**ADDENDUM TO
ENVIRONMENTAL ASSESSMENT
for the
MICRODREDGING OF TUMON BAY
ADJACENT TO THE FUJITA HOTEL**

**Prepared for
T & NN INTERNATIONAL**

RESPONSE TO COMMENTS BY
GUAM DEPARTMENT OF AGRICULTURE

REVISED FIGURE 2-3: BATHYMETRY IN VICINITY OF PROPOSED DREDGE ZONE

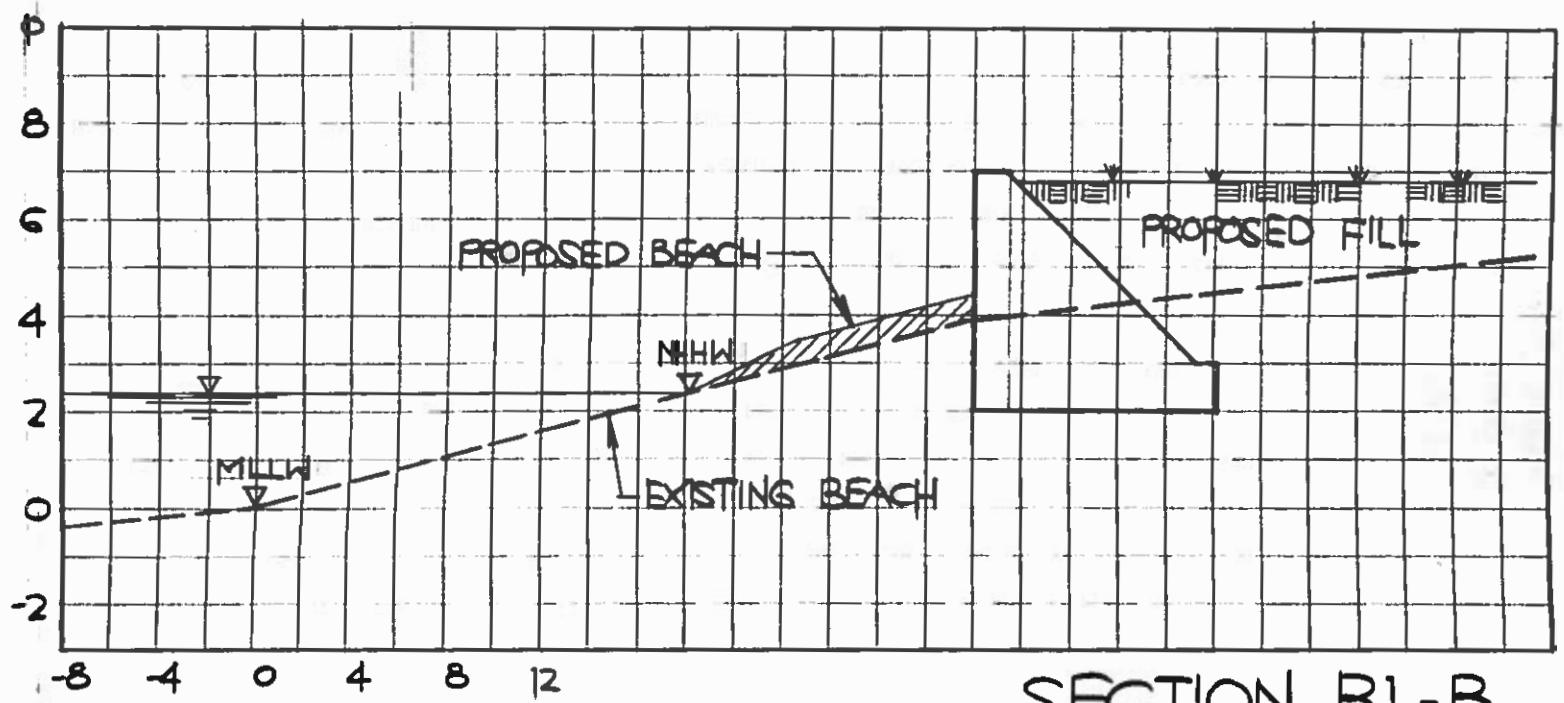
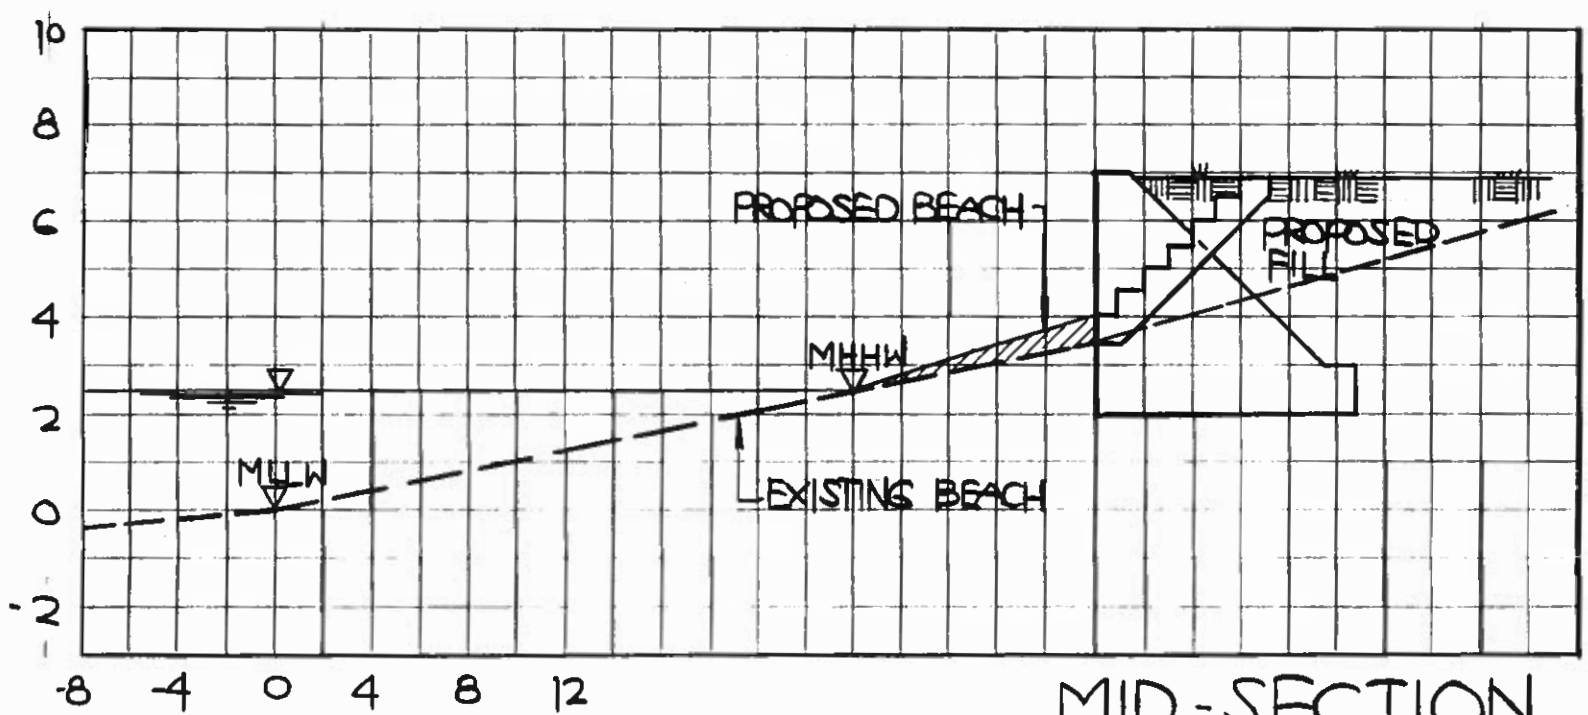
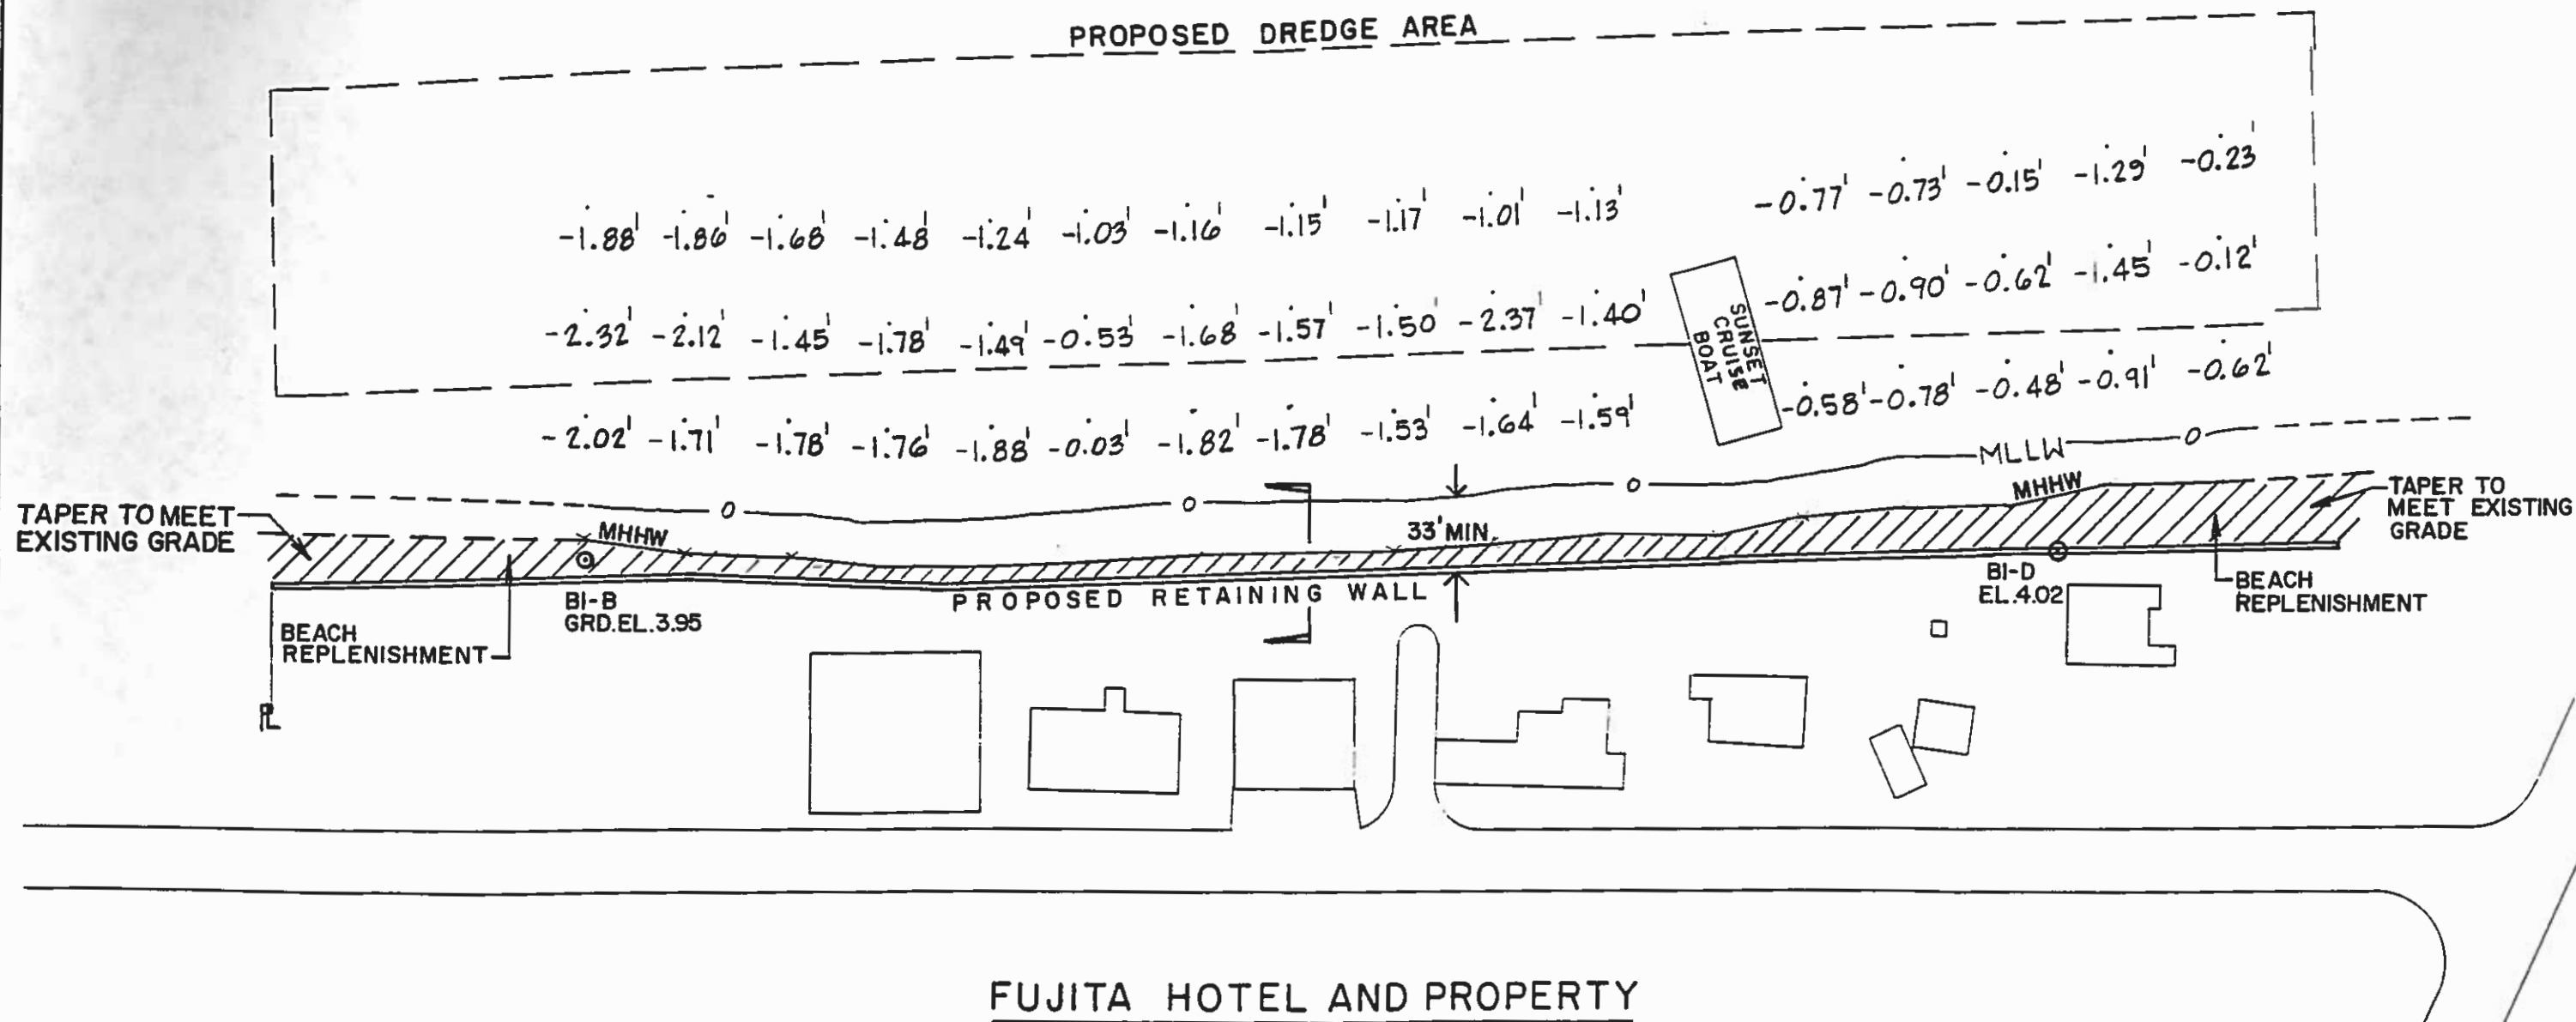
COMMENT # 9: The set back requirements (Section 13410 et. seq. of the Guam Coastal Management Program) demand that the seawall be placed 10 meters from the MLLW mark. The present designs indicate this wall will be placed 15 ft. above the MHHW mark which will be inside the Territorial Seashore Preserve.

The proximity of the seawall to the MHHW mark will create backwash and undercutting beach erosion during periods of heavy storm waves. The wall needs to be moved landward to avoid this problem.

RESPONSE: The seawall has been revised to be no closer than 10 meters to the MLLW line. Only the center portion of the wall is changed from the original proposal. This change is to comply with the Territorial Seashore Preserve.
